ADDENDUM NO. 2

REPLACEMENT OF SEVEN PASSENGER BOARDING BRIDGES

SYRACUSE HANCOCK INTERNATIONAL AIRPORT
SYRACUSE REGIONAL AIRPORT AUTHORITY
SYRACUSE, NEW YORK

IFB REFERENCE #2022-1 & # 2022-2

SHEET NUMBER:
ED-101

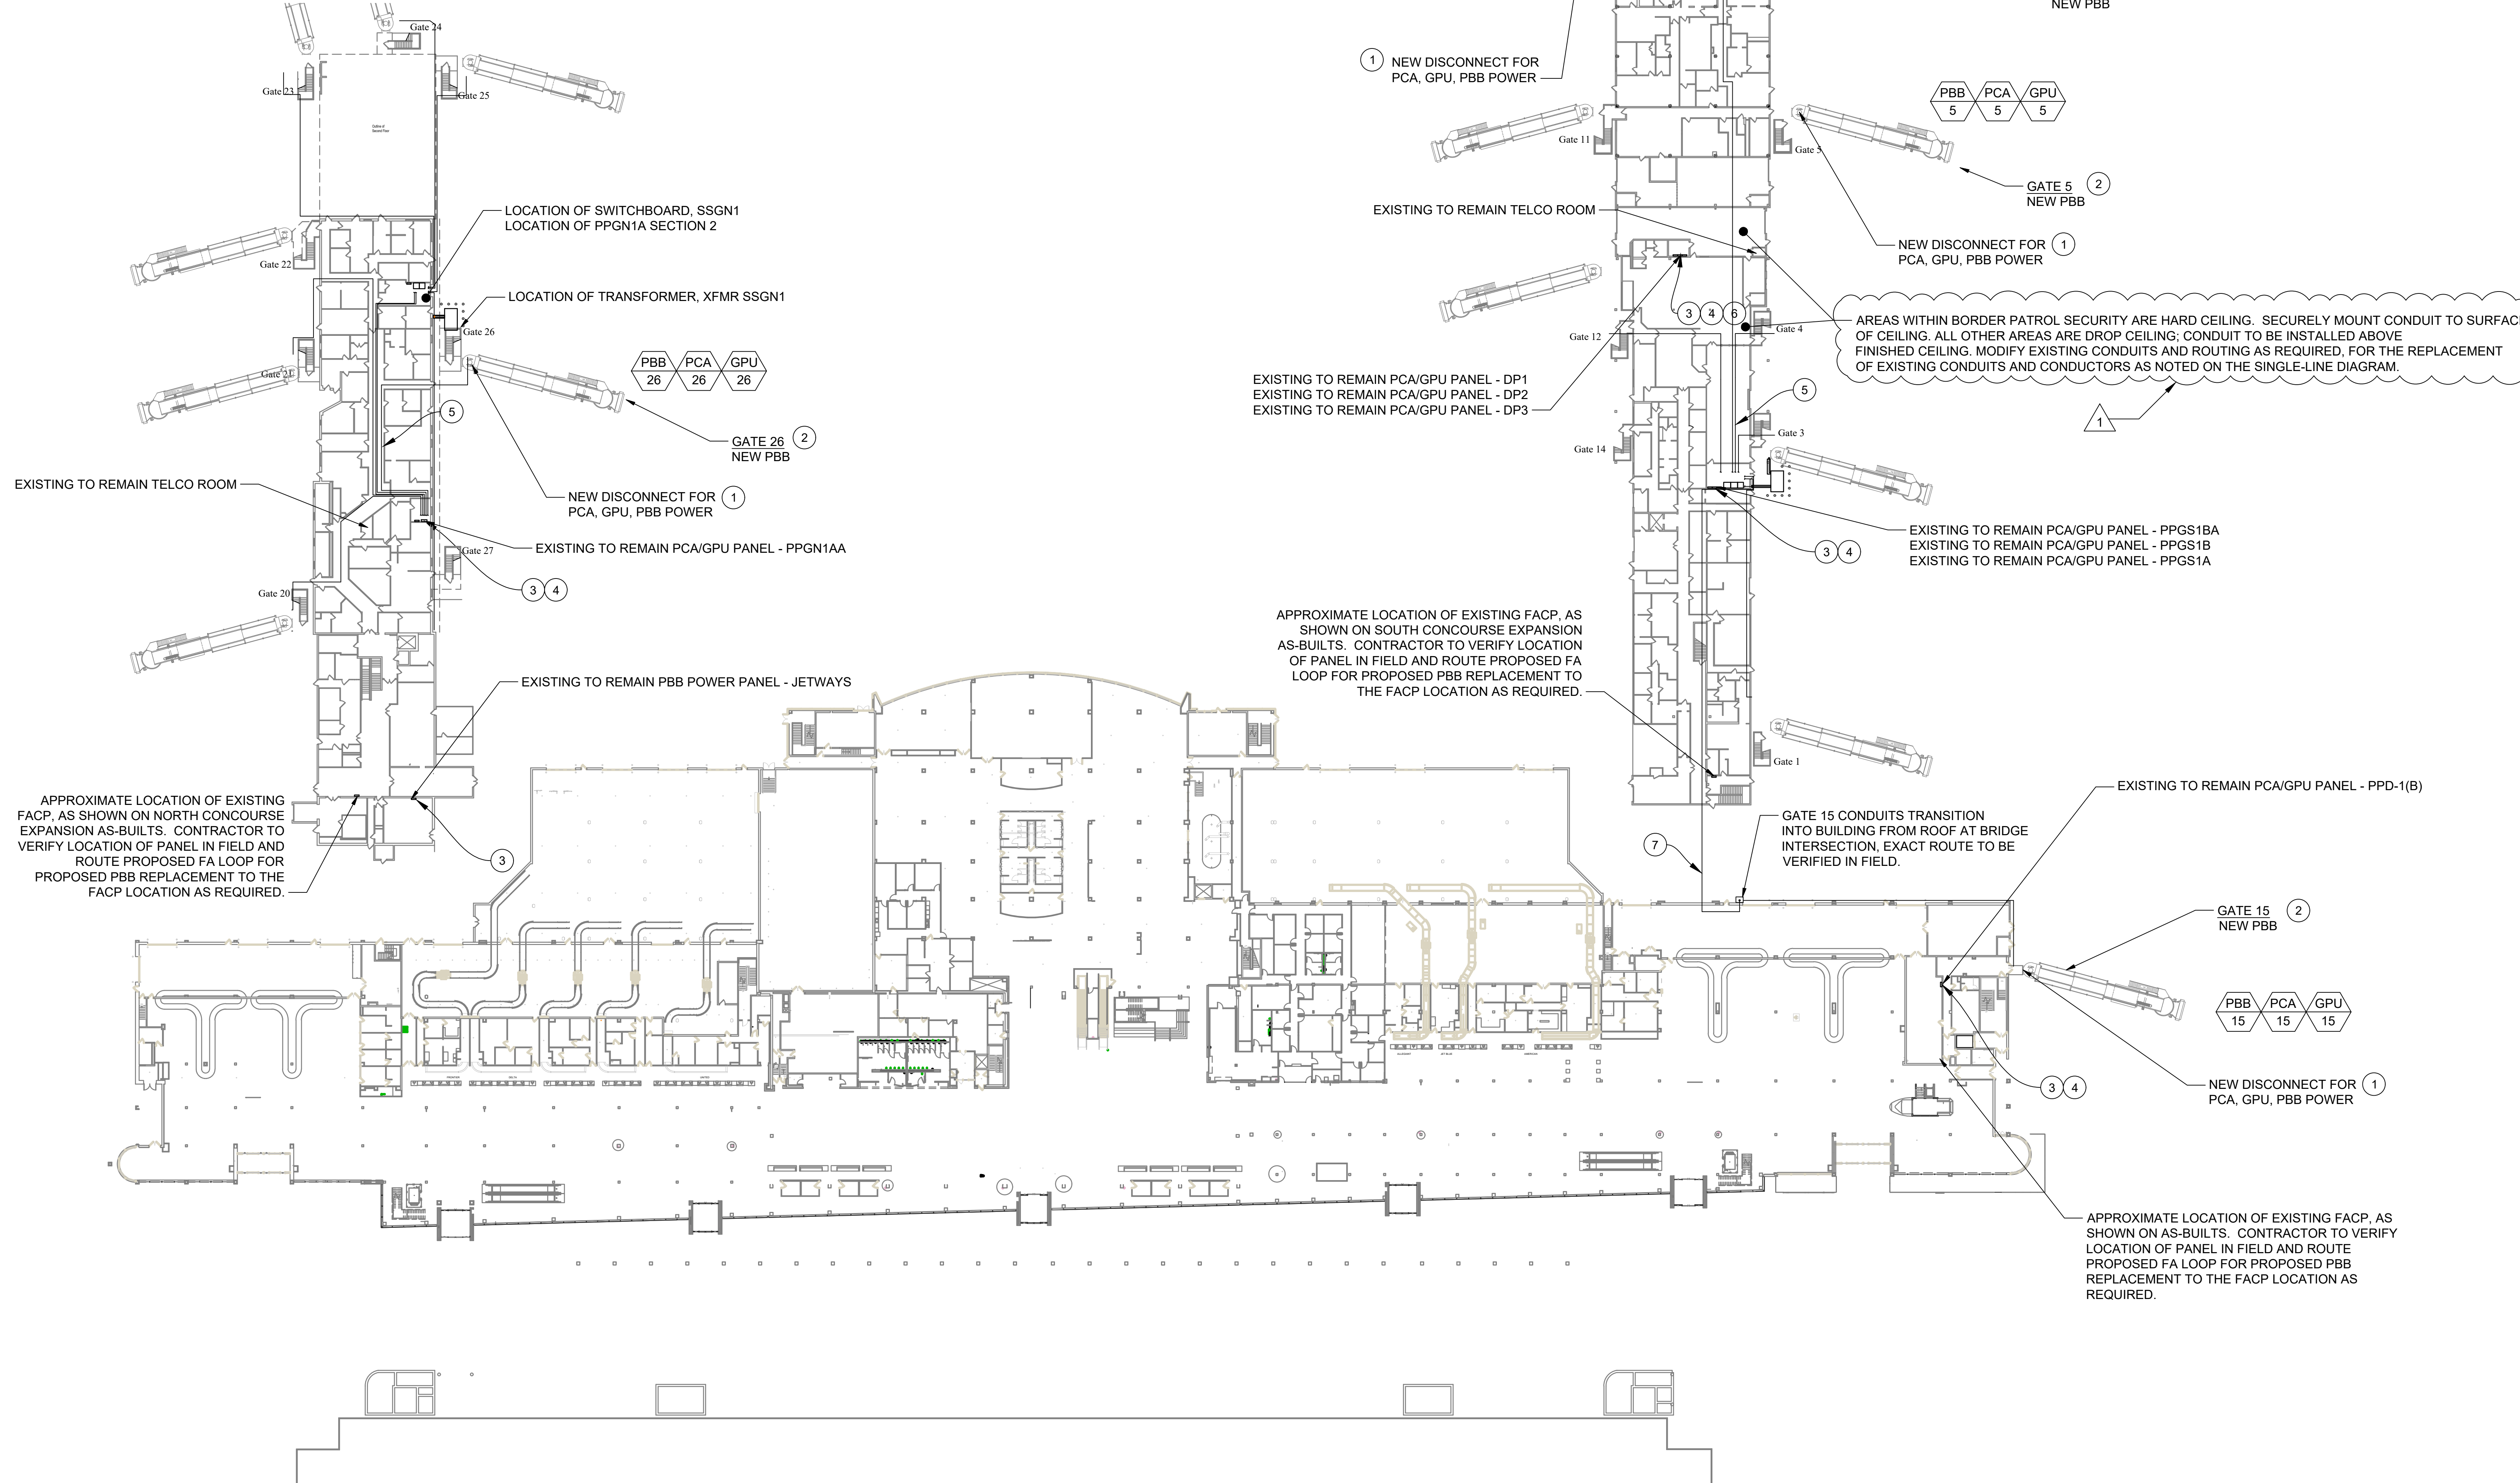
1. **CA-002 – Passenger Boarding Bridge Equipment Details**
 - a) Clarified General Notes
 - b) Changed Baggage Conveyor to Bag Slide
2. **ED-101 – First Floor Electrical Demolition Plan**
 - a) Clarified call-out for work in Border Patrol Security area
3. **E-101 – First Floor Electrical Power Plan**
 - b) Clarified call-out for work in Border Patrol Security area
4. **E-602 – PBB Electrical Connection Details**
 - a) Clarified call-outs for PBB, PCA and 400 Hz feeders
 - b) Added Keyed Note 1 to clarify electrical requirements

Item	Date	QUESTIONS	Date	RESPONSE
9	1/21/2022	Sheet ED-101 has a note that "areas within Border Patrol Security" are hard ceilings and we are to "mount to ceiling." Please confirm this means we mount exposed conduit and pull-boxes within this space. Please also confirm the existing hard ceiling type (drywall, metal panel etc) and the height of ceiling.	1/27/2022	Conduits and pullboxes to be provided in the Border Patrol Security area shall be securely surface mounted to the ceiling. Bidders shall be responsible for verifying the height of the ceiling.
10	1/21/2022	Is there a preferred or required Fire Alarm Contractor for any FACP work or FA scope? Similarly, is there a preferred or required SAACS contractor and/or IT contractor at Syracuse?	1/27/2022	Simplex/Johnson Controls are preferred as they handle the final connections to the existing equipment, but other certified contractors have completed work at the airport in the past,

DRAWN BY: **M. CERBIN** DATE: **01/11/22** SCALE(S) NOTED ON THIS SHEET ARE BASED ON A FULL SIZE 30"x42" SHEET
 CHECKED BY: **M. MORRIS**
 SHEET NUMBER: **E-602**

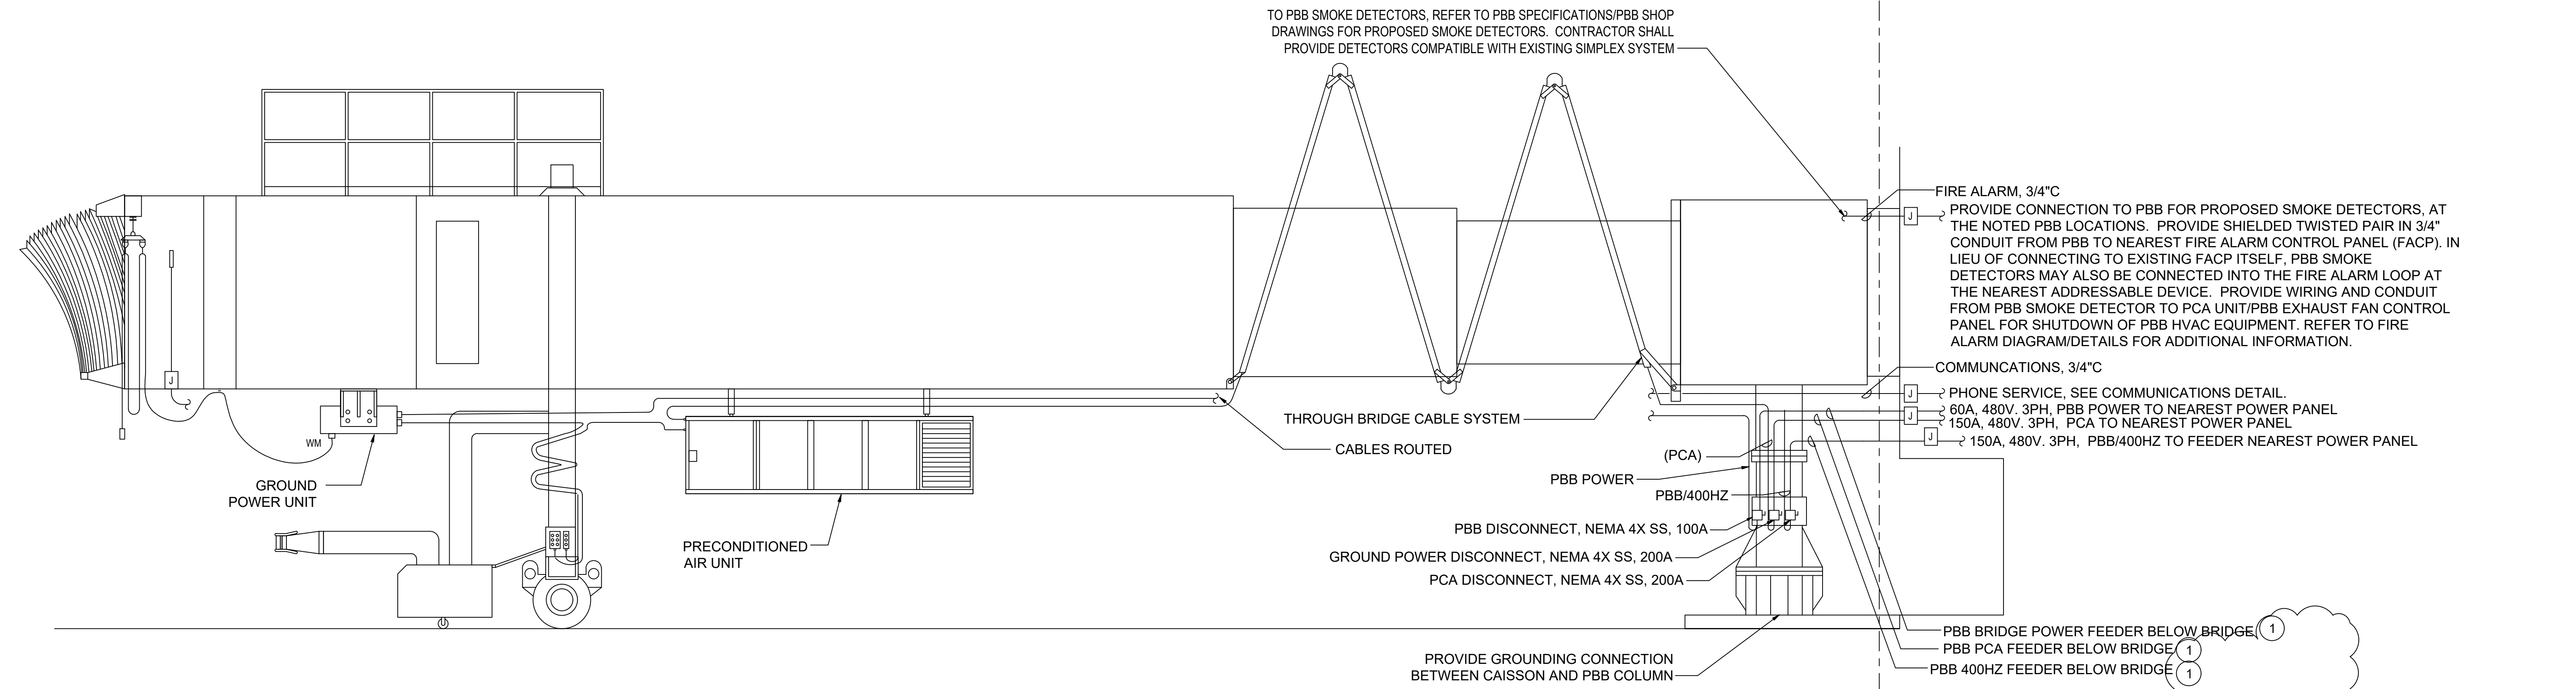
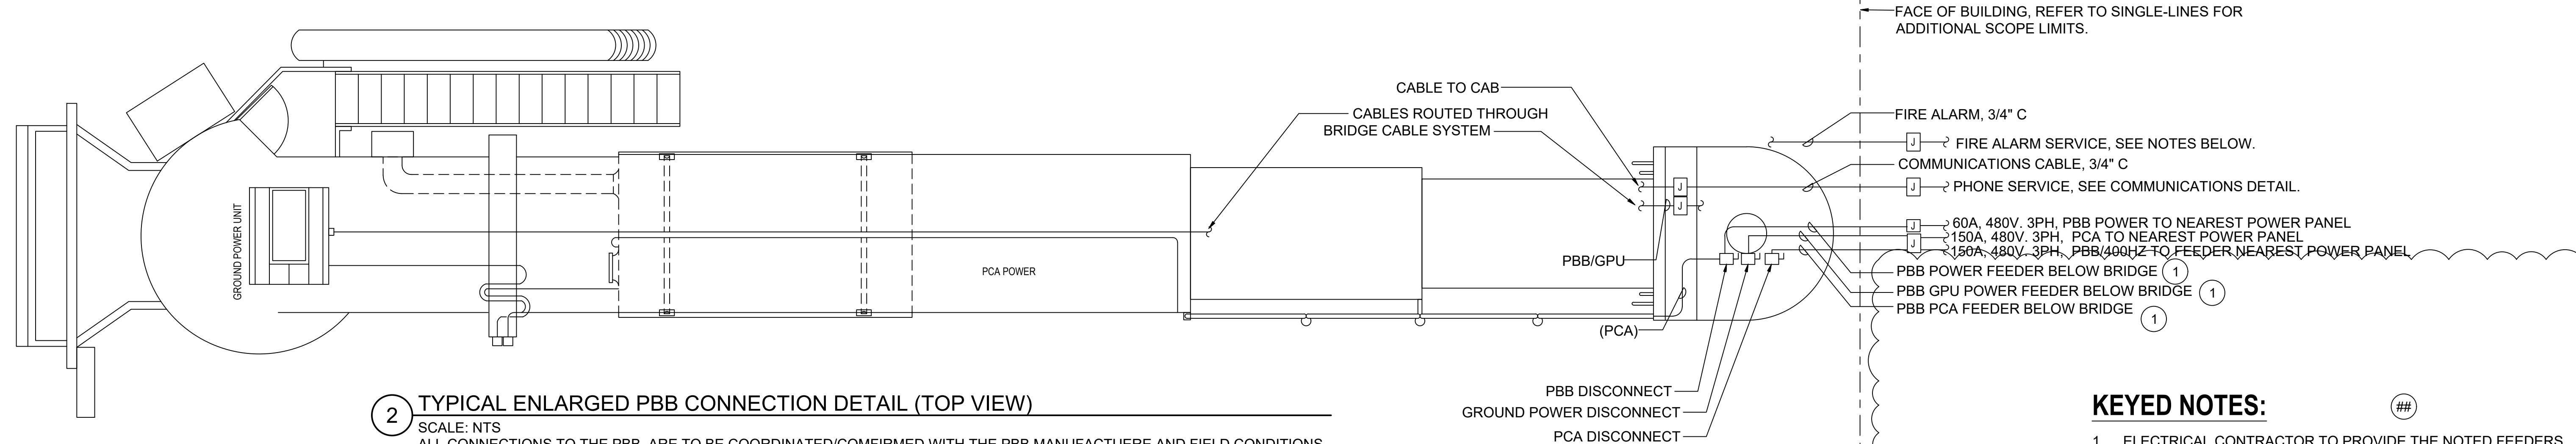
8	1/21/2022	Sheet E-602 states "PBB Bridge Power," "GPU" and "PCA" feeder power below bridge "by others." Please confirm if this is accurate or if the PBB Contractors are supposed to be responsible for the "feeder power below bridge" as indicated on other drawings. Additionally, please confirm PBB Contractor is responsible for all electrical work shown E and ED series drawings.	1/27/2022	The feeder power for the PBB, GPU and PCA between the building and the disconnect switch at the rotunda shall be provided by the Electrical Construction Contractor. The Electrical Construction Contractor shall also terminate the secondary connection for the PBB, GPU and PCA at the disconnect switch. The General Construction Contractor is responsible for all other electrical work associated with the PBB, GPU and PCA "downstream" of the disconnect switch.

- ELECTRICAL CONTRACTOR TO PROVIDE THE NOTED FEEDERS (PBB POWER, GPU POWER, AND PCA POWER) TO PBB ROTUNDA SUPPORT COLUMN, UP TO AND INCLUDING THE DISCONNECTING MEANS AND TERMINATIONS OF THE SECONDARY CONDUCTORS IN THE NEMA 4X STAINLESS STEEL DISCONNECT. SECONDARY CONDUCTORS SHALL BE PRESENTED TO THE DISCONNECT BY THE GENERAL CONSTRUCTION CONTRACTOR. ELECTRICAL CONSTRUCTION CONTRACTOR SHALL INCLUDE ALL COSTS ASSOCIATED WITH COORDINATION, CONDUIT, CONDUCTORS, HANGERS/SUPPORTS AND OTHER ASSOCIATED APPURTENANCES WITH THE GENERAL CONSTRUCTION. ELECTRICAL CONSTRUCTION CONTRACTOR SHALL ALSO CARRY COSTS FOR COORDINATING PROPOSED CONDUIT ROUTING BELOW THE PBB TO THE DISCONNECT LOCATION SHOWN WITH THE GENERAL CONSTRUCTION CONTRACTOR. REFER TO SINGLE-LINES DRAWINGS AND SPEC 34 77 13 - PASSENGER BOARDING BRIDGE.
